DENVER RTD EAGLE P3
COMMUNICATION SYSTEM

FIELD MODIFICATION INSTRUCTIONS
FMI #7: HARDWARE MODIFICATION

CONTRACT NO.	**P110701149**
CDRL NO.	**N/A**
WIS DOC. NO.	**42A-2016-0027**
REVISION:	**1.1**
DESIGNED:	**D. S. JANG**
REVIEWED:	**J. Y. LEE**
APPROVED:	**B. J. JONE**
DATE:	**9/08/2016**

Figure 2 – AF Board schematics

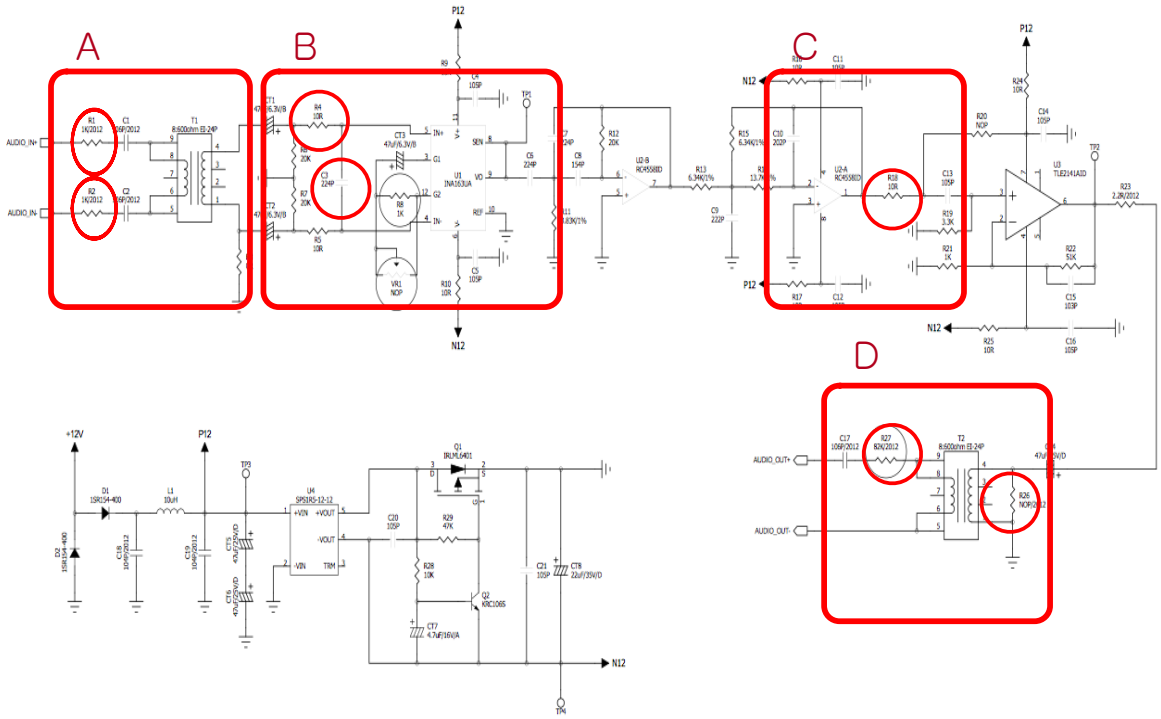
Items	First Improvement (End of June)	Last Improvement (End of August)	Remarks
A(R1)	1K Ω → 0 Ω	Same as First Improvement	Resistor
A(R2)	1K Ω → 0 Ω	Same as First Improvement	Resistor
B(R4)	-	10 Ω → 47K Ω	Resistor
B(C3)	-	224P → 102P	capacitor
C(R18)	-	10 Ω → 47K Ω	Resistor
D(R26)	-	NOP → 8.2 Ω	Resistor
D(R27)	-	82K Ω → 0 Ω	Resistor

- A : The audio input impedance change
  - When R1, R2 component changed (1kΩ ->0Ω), the line impedance changed from 1k Ω to 0Ω and remove the derelict noise signal on the transformer (TRF – T1 600:8).
- B : Noise remove
  - The noise signal is filtered by changing the input resistance (10Ω -> 47kΩ) of R4 component due that the input audio signal includes the noise.
- C : The audio frequency change (B.P.B)
  - The audio frequency from 4 kHz to 5 kHz is partially blocked by changing R18 component.
- D : Output impedance change
  - The impedance changed from HI to LO. The noise is blocked and the audio output signal is filtered by changing the R27 component.

Figure 3 – AF Board Location

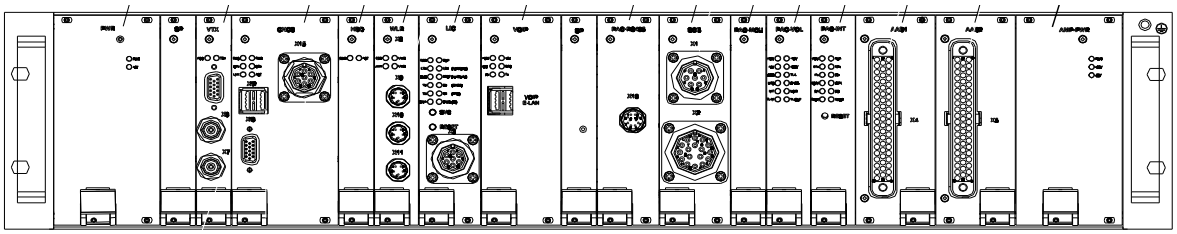
4) Plug in the Audio Filter (AF) board to the slot where the SP panel was removed
